GUNNISON COUNTY, COLORADO
COMMUNITY DEVELOPMENT DEPARTMENT, ENVIRONMENTAL HEALTH OFFICE STAFF REPORT

R&D Development, LLC

Application No:	OWTS-19-00287
Date application scheduled with EH Board:	June 18, 2020
Prepared by:	Crystal Lambert, Building & EH Official

O.W.T.S. Variance Request & Proposed Design Report

1 SITE PLAN
3/4" = 1'-0"

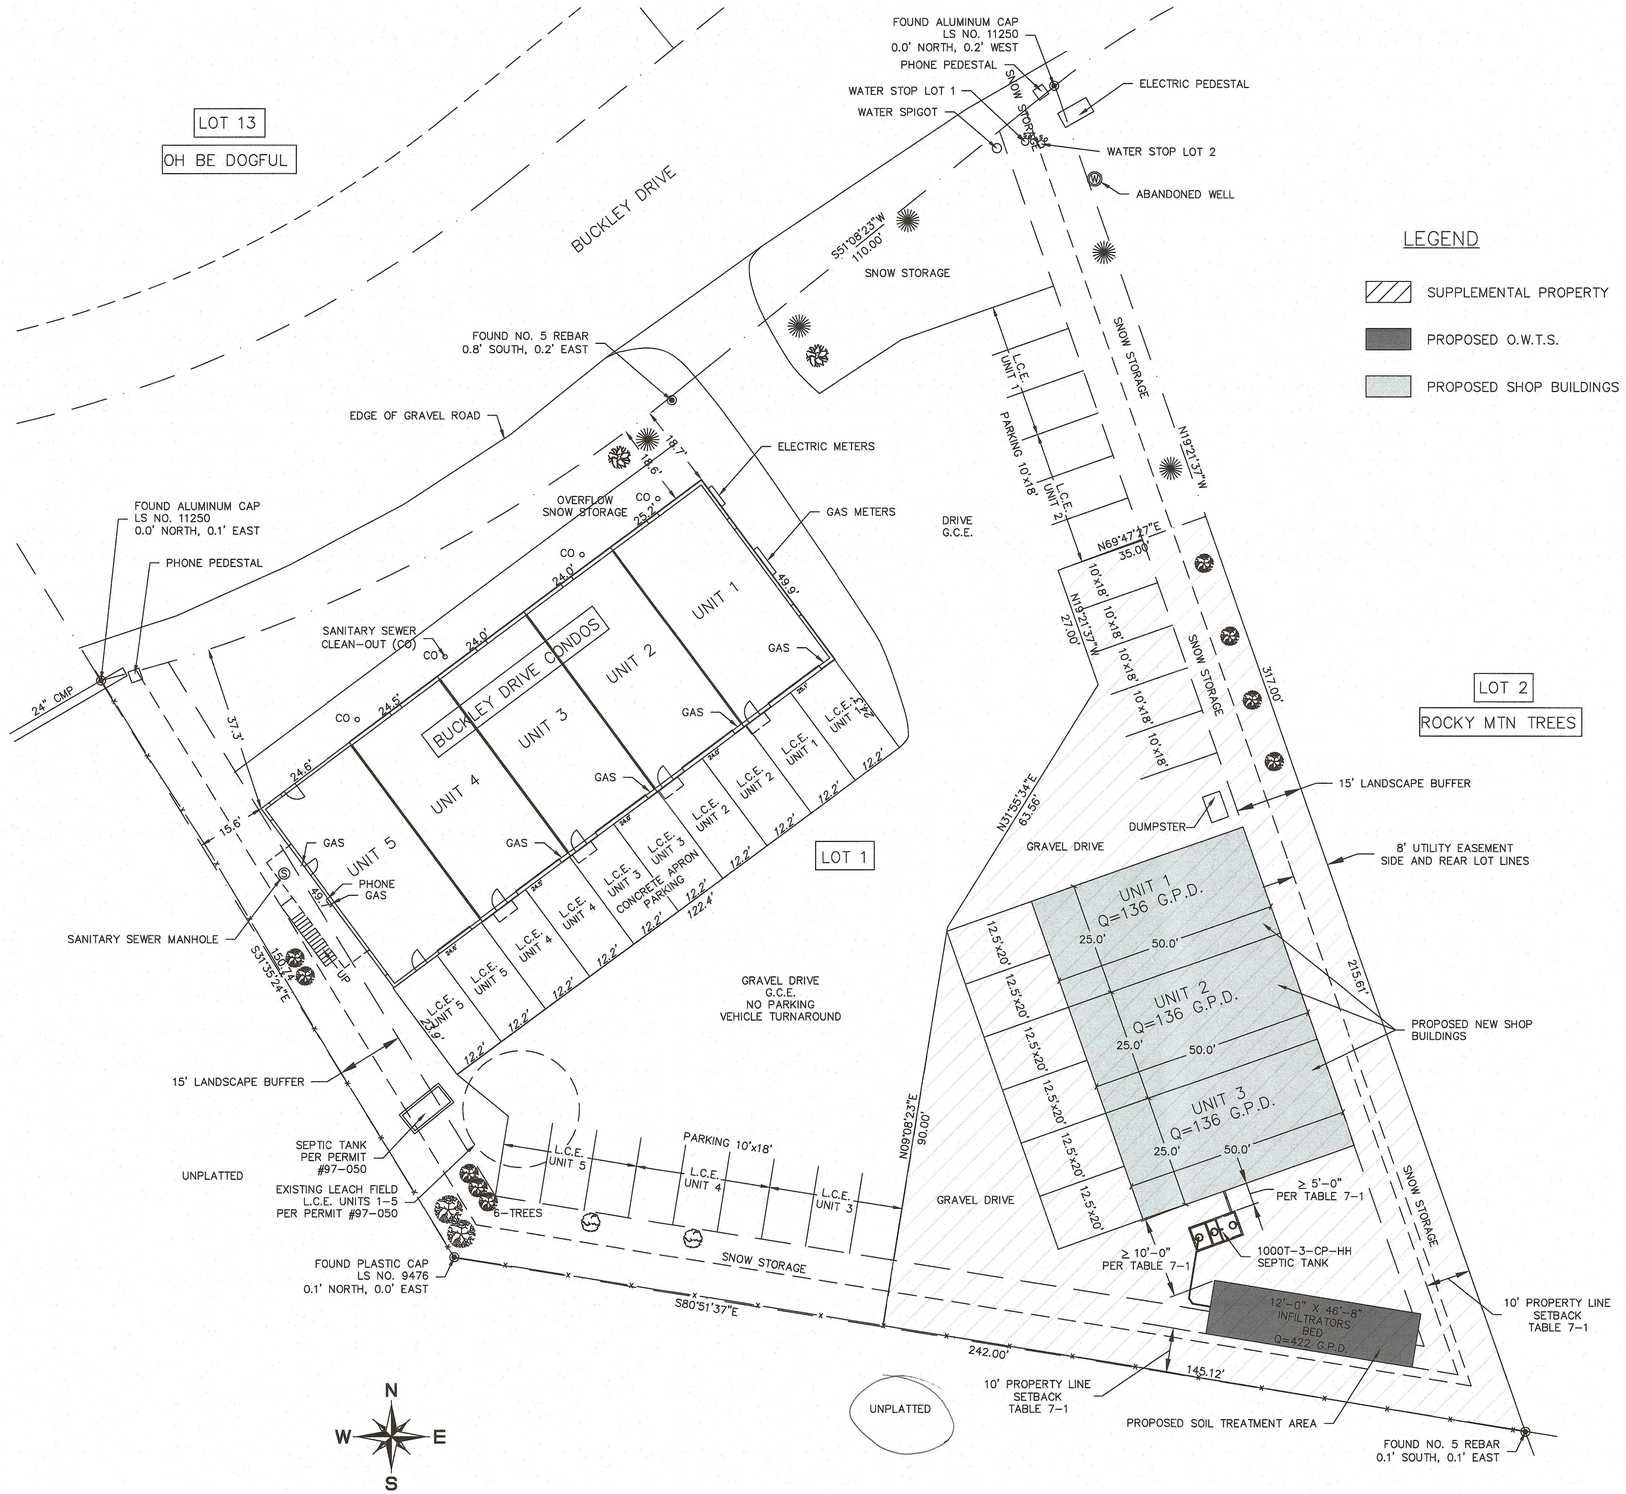
***Section 3.M.2.*: Prohibitions on the granting of variance requests**	
Prohibitions on the granting of variance requests:	**Staff comments:**
No variance shall be issued where the property can accommodate a conforming OWTS. Section 3.M.2.a.	The OWTS will conform to the technical and design requirements. The variance request is for a second OWTS on a parcel. If the variance request is approved, a proposed design will only be accepted for an OWTS permit if it meets the design requirements of the OWTS Regulations.
No variance shall be issued to mitigate an error in construction involving any element of property improvements. Section 3.M.2.b.	There is no known error of construction involving any element of the property improvements.
No variance shall be allowed on the grounds of cost of compliance. Section 3.M.2.c.	A claim of cost burden has not been made.
No variance shall be issued if it will result in a setback reduction to an offsite physical feature that does not conform to the minimum setbacks defined in Table 7-1 of this regulation without proof of compliance of Section 3.M.5. Section 3.M.2.d.	The minimum setbacks to off-site physical features appear to be met with the proposed development plan.

No variance shall be issued if it reduces the separation to ground water or bedrock based on the level of treatment in Table 7-2.Section 3.M.2.e.	A limiting layer has not been encountered and is not anticipated in the area.
No variance from the horizontal setback from a well shall be issued unless it also meets the variance requirements of the Board of Examiners of Water Well Construction and Pump Installation Contractors. Section 3.M.2.f.	The parcel and surrounding parcels are served by a central water supply.
No variance shall be issued for the installation of a higher level treatment system based on sizing or separation reductions without the Department having a maintenance and oversight program. Section 3.M.2.g.	A higher level treatment system is not proposed.

It appears that the proposed OWTS design meets the design criteria and setback distance requirements of the Gunnison County OWTS Regulations. Designing one system to serve the existing and proposed buildings on the parcel is not technically feasible and the system could be susceptible to failures. The existing system on the parcel is serving an existing shop building with a residence above and has recently been inspected and shown to be in working order. Therefore, staff recommends approval of R&D Development, LLC's application for a variance to the Gunnison County OWTS Regulations, Section 3.A.10, for a second OWTS on a parcel.
